## REMARKS

Reconsideration of the application is requested. Claims 1 through 14 are now in the application. Of these, Claims 7 through 14 have been withdrawn from consideration as being directed to non-elected subject matter. Claims 7 through 14 are being retained in the application subject to Applicant's option to file a divisional application directed thereto.

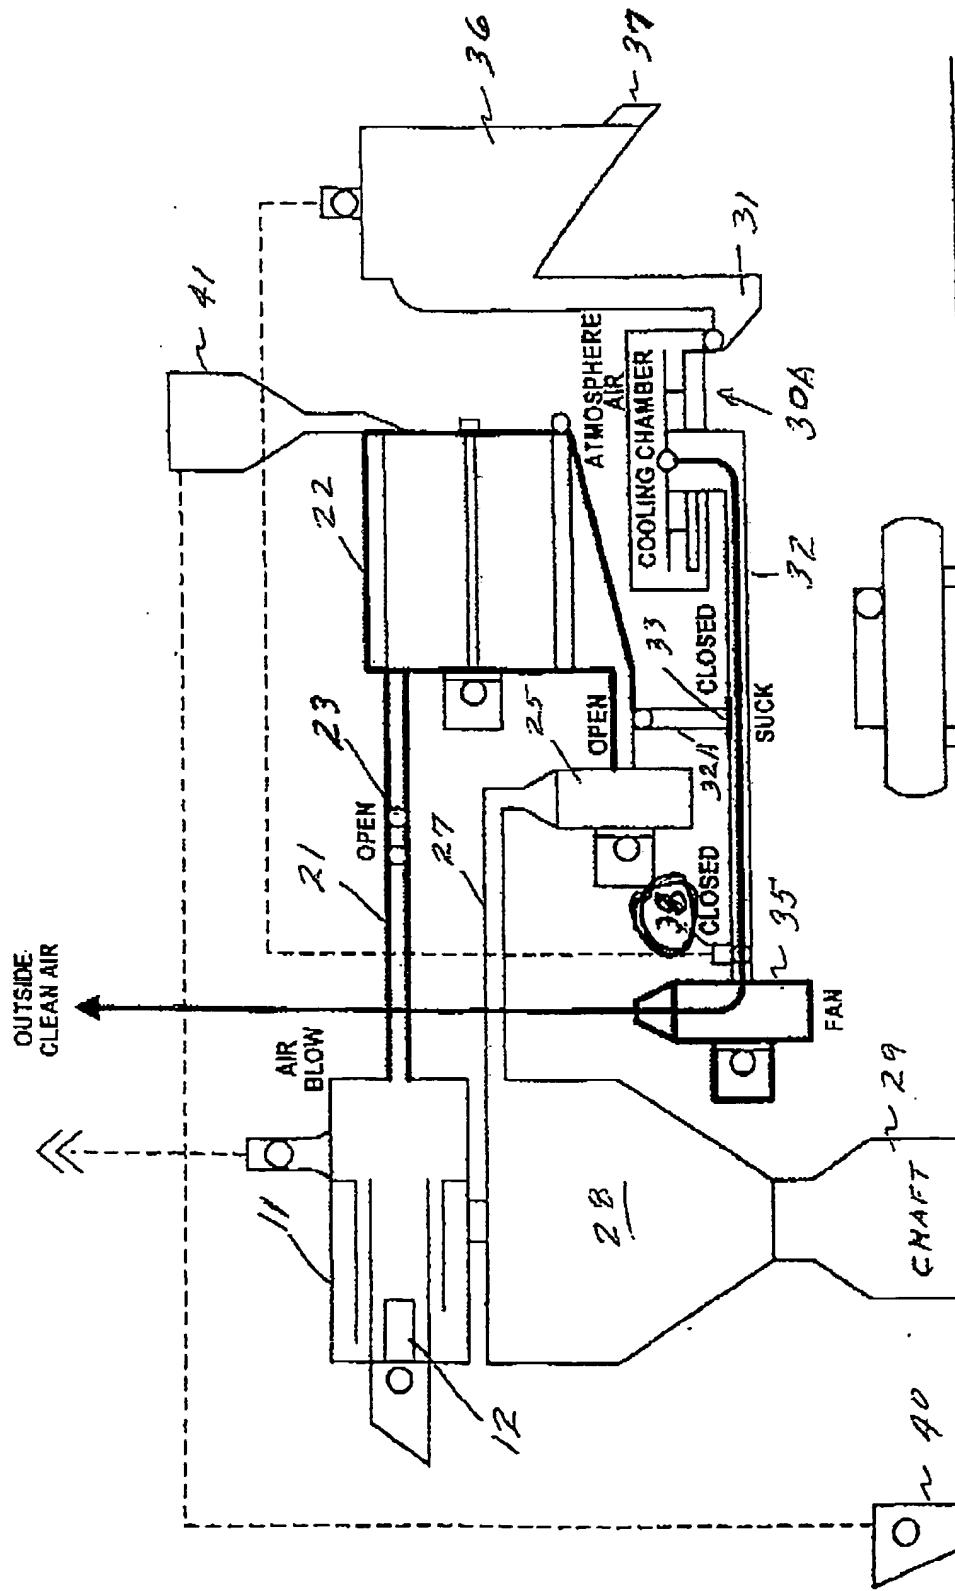
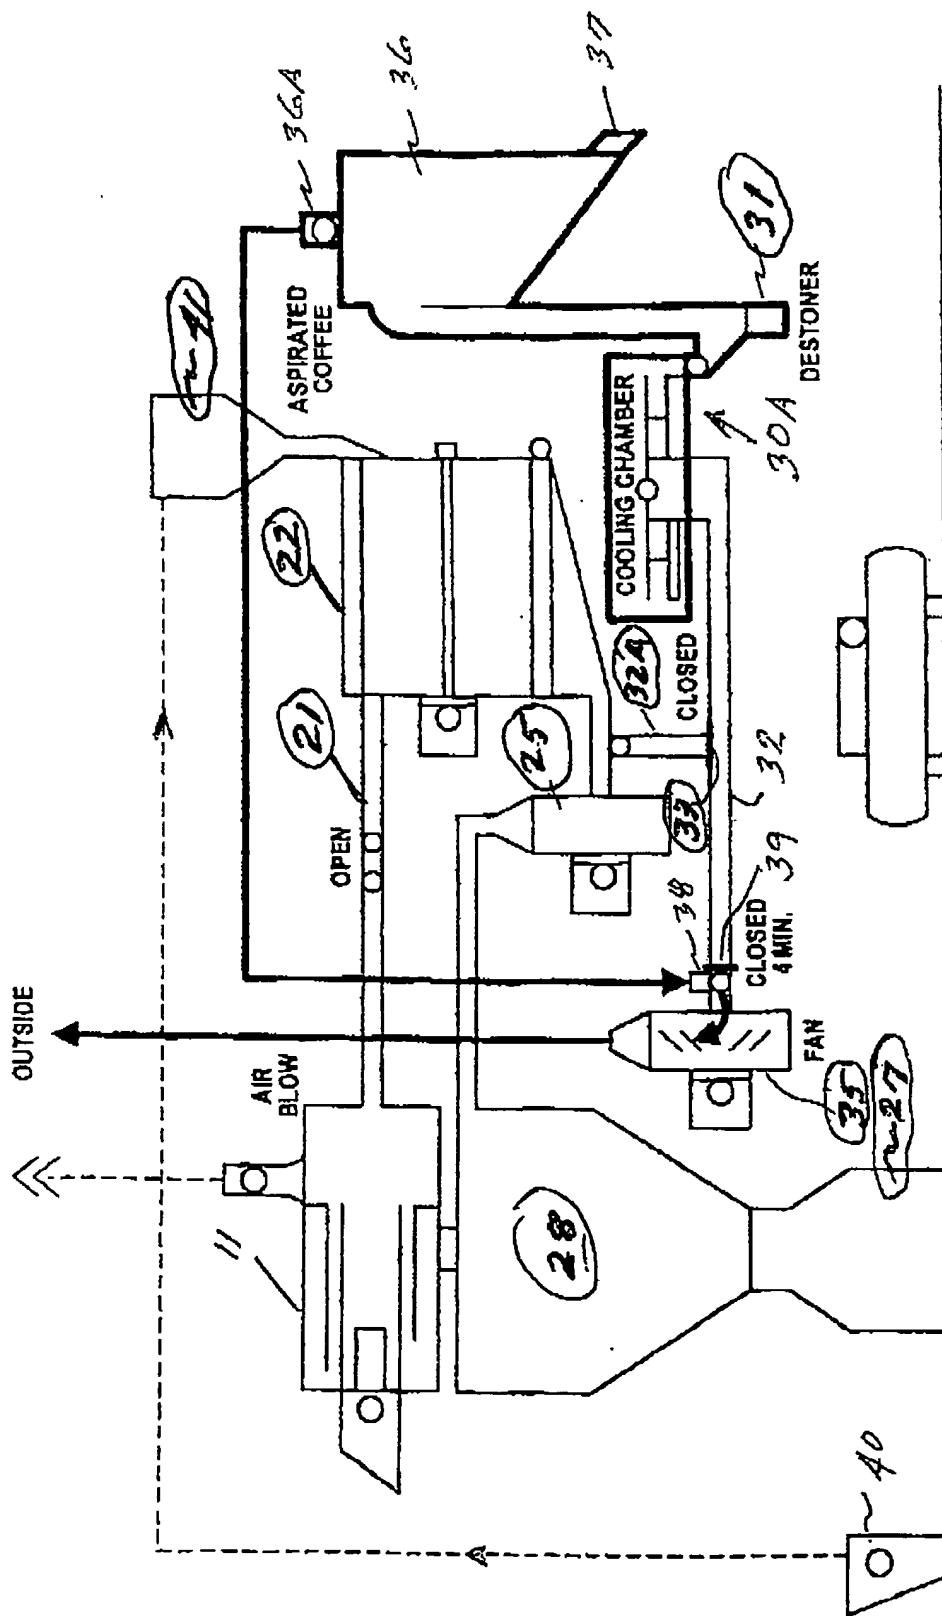
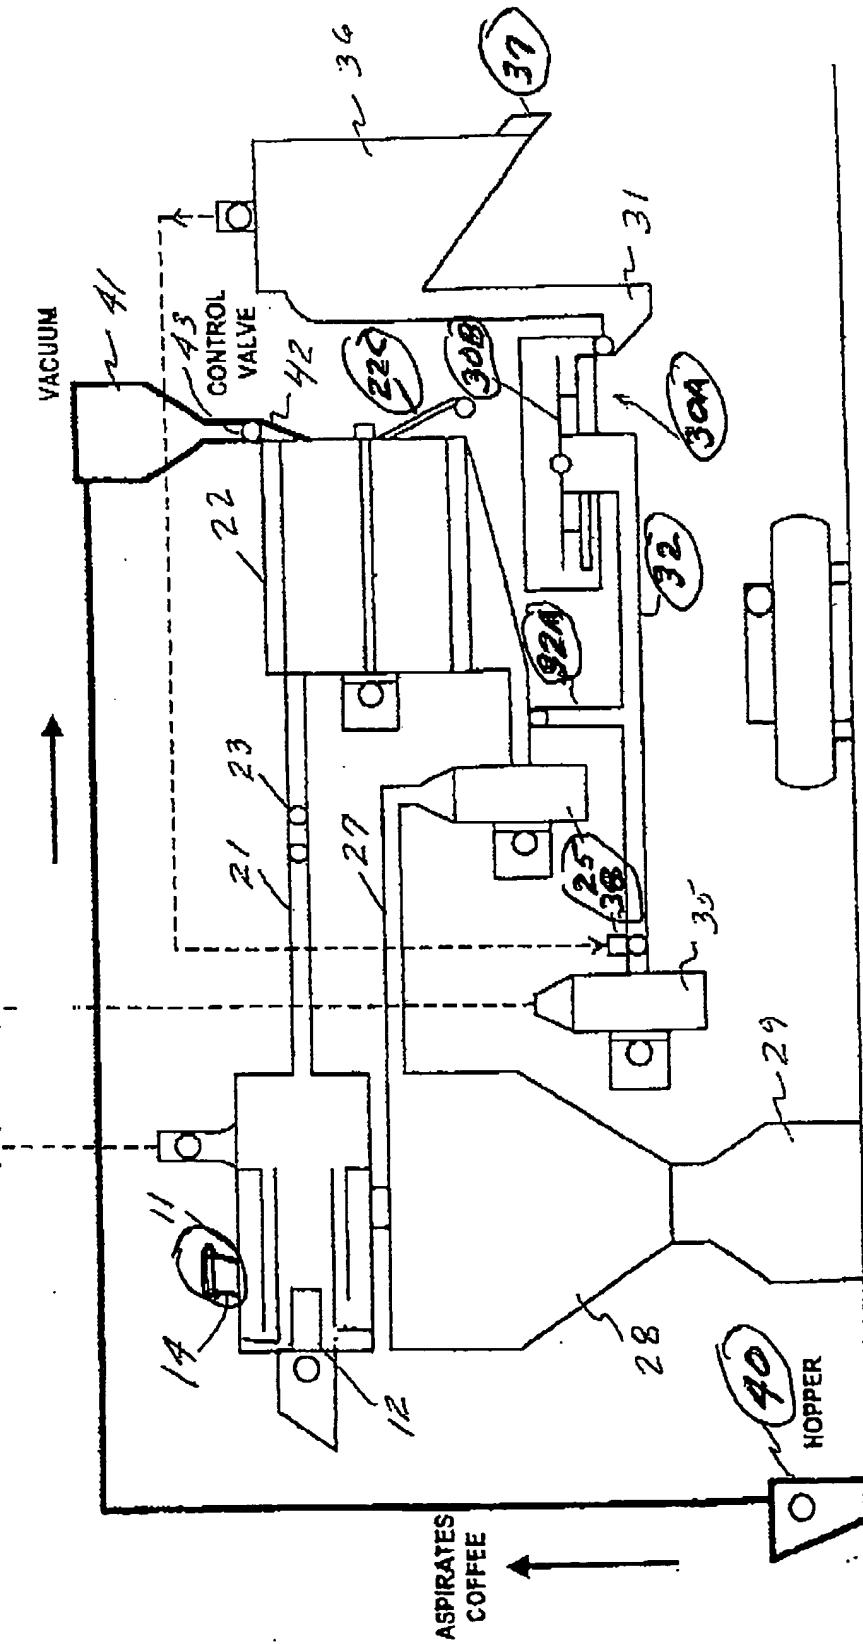
The Examiner's general objection to the drawings, as indicated in paragraph 4 of the Examiner's action, has also been noted. As no specific unreadable or non-uniform lining of the drawings have been identified, the Applicant is submitting herewith replacement sheets with respect to Figs. 1 through 6 in an effort to obviate any unreadable and/or non-uniform lining in accordance with 37 CFR 1.121(d)1.

With respect to drawing Figs. 1 through 5, it is to be noted that the highlighted or darkened lines in Figs. 1 through 5 respectively are intentionally highlighted so as to emphasize the various steps of the roasting process in an effort to better illustrate and understand the subject matter being claimed. Since the drawings comprise a diagrammatic illustration of the invention, it is submitted that emphasizing the various features and steps of the claimed invention, as shown in Figs. 1 through 5 to better illustrate the invention, should not be considered as objectionable. Reference is made to the drawing descriptions on page 5 of the specification wherein, for example, Fig. 1 is defined as a diagrammatic side view of a coffee roasting apparatus embodying the present invention emphasizing the roasting phase. Fig. 2 is described as emphasizing the first step of the cooling phase. Fig. 3 is defined as emphasizing the second step of the cooling phase. Fig. 4 is defined as emphasizing the final phase of the roasting cycle. Fig. 5 is defined as emphasizing the step of loading the green coffee into the roasting oven.

herewith a marked up copy of the drawings presented in the replacement sheets to indicate the corrections in red that have been made on the replacement sheets.

It is submitted that the difference in the lines showing on Figs. 1 through 5 renders a better and more comprehensive
